5928-07-20246
December 28, 2007

Three Mile Island Nuclear Station, Unit 1
Facility Operating License No. DPR-50
NRC Docket No. 50-289

Subject: Three Mile Island Unit 1 Supplemental Response to NRC Generic Letter 2004-02, "Potential Impact of Debris Blockage on Emergency Recirculation during Design Basis Accidents at Pressurized-Water Reactors"

Figure 1. TMI Unit 1 Schematic of the Emergency Core Cooling System and Containment Spray Systems

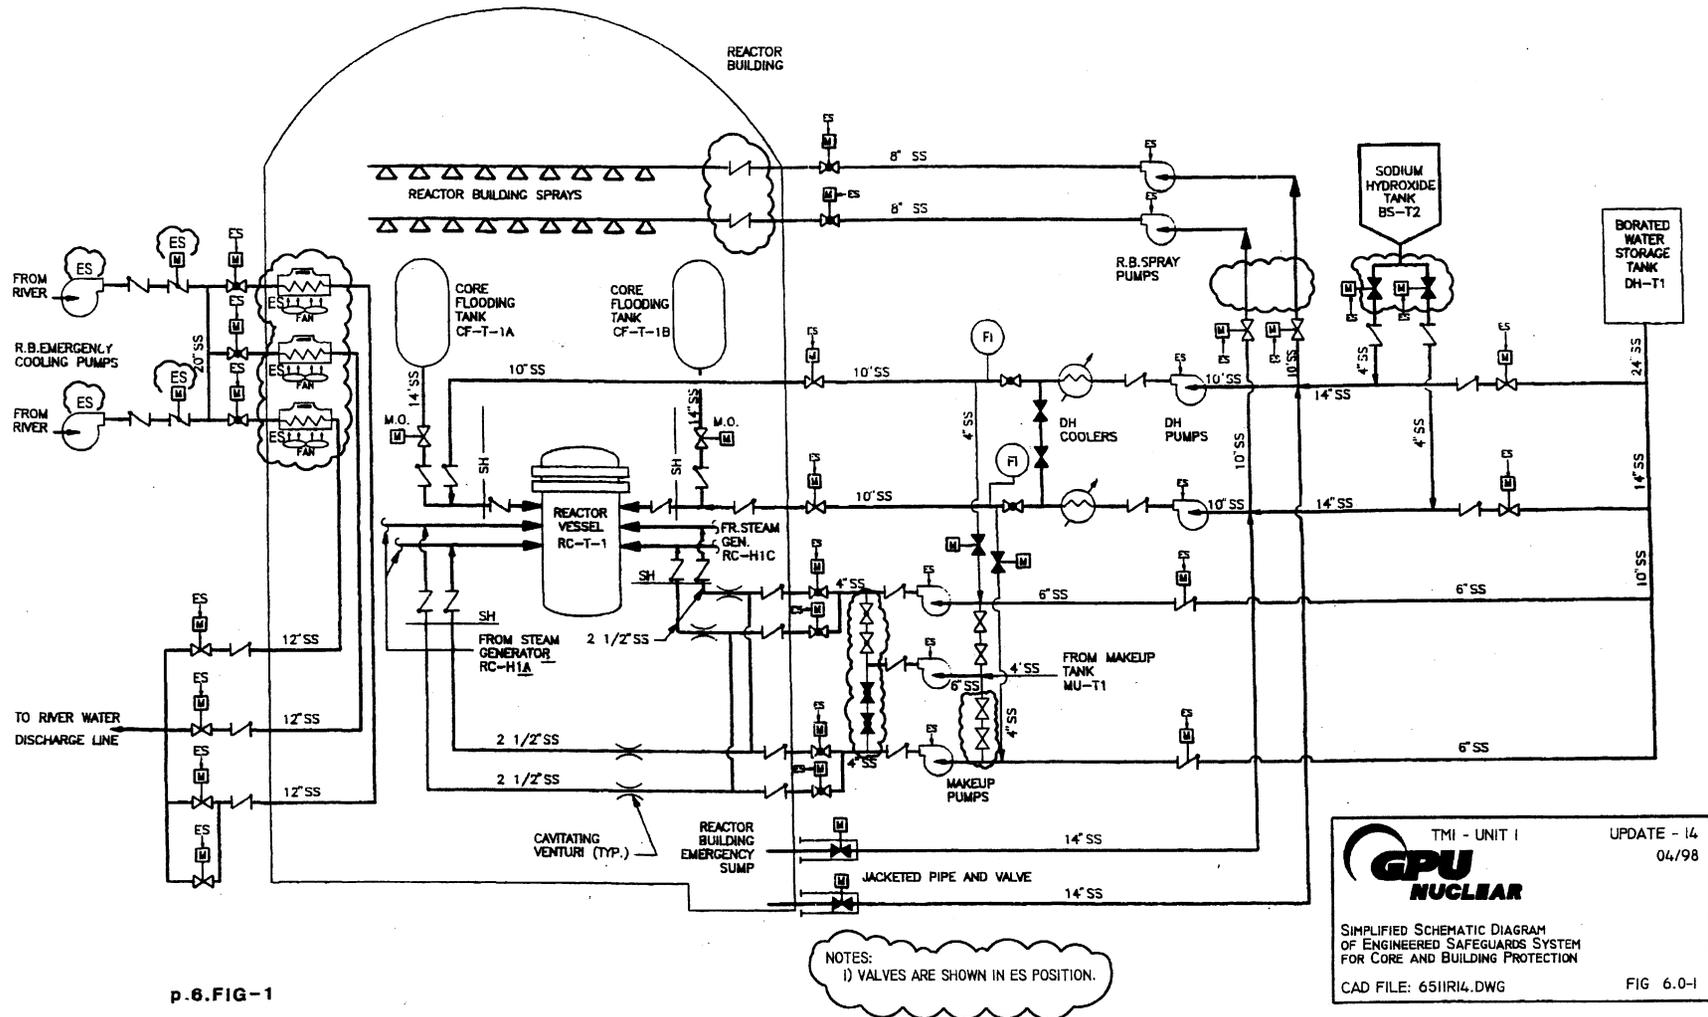
- 1. Provide a schematic diagram of the emergency core cooling system (ECCS) and containment spray systems (CSS).*
- 2. Provide the minimum submergence of the strainer under small-break loss-of-coolant accident (SB LOCA) and large-break loss-of-coolant accident (LB LOCA) conditions.*

AmerGen Response to Issue 3f.1:

Figure taken from TMI Unit 1 UFSAR (Reference 18) Figure 6.0-1

Figure 3. Schematic of the TMI Unit 1 Reactor Building Sump

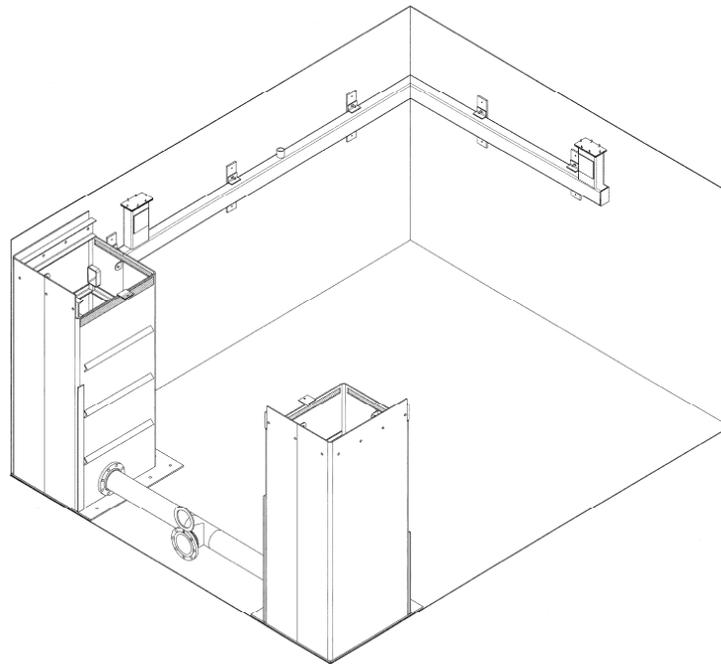
- 1. Provide a description of the major features of the sump screen design modification.*
- 2. Provide a list of any modifications, such as reroute of piping and other components, relocation of supports, addition of whip restraints and missile shields, etc., necessitated by the sump strainer modifications.*

The sump was divided into a normal “wet” sump and an ECCS “dry” sump. The new normal sump design is two (2) boxes that are approximately 3 ft x 2.5 ft in plan and 6 ft in height located in the corners at the west end of the existing sump pit on either side of the ECCS suction pipes.

The ECCS sump is the remaining volume of the pit. The “box” strainer assembly was replaced with an array of “top hat” strainer modules. The top hat module is comprised of two perforated plate tubes (8” and 12” diameter) forming an annular flow area between. The perforated plate has 3/32” holes and the annular region contains a DBE (wire mesh filter element) to minimize debris bypass that can negatively affect downstream components⁹. There are a total of 81 top hat modules; 79 modules are 83” in long, and two are 48” long¹⁰. The surface area of the strainer has increased from 224 ft² to 2580 ft².
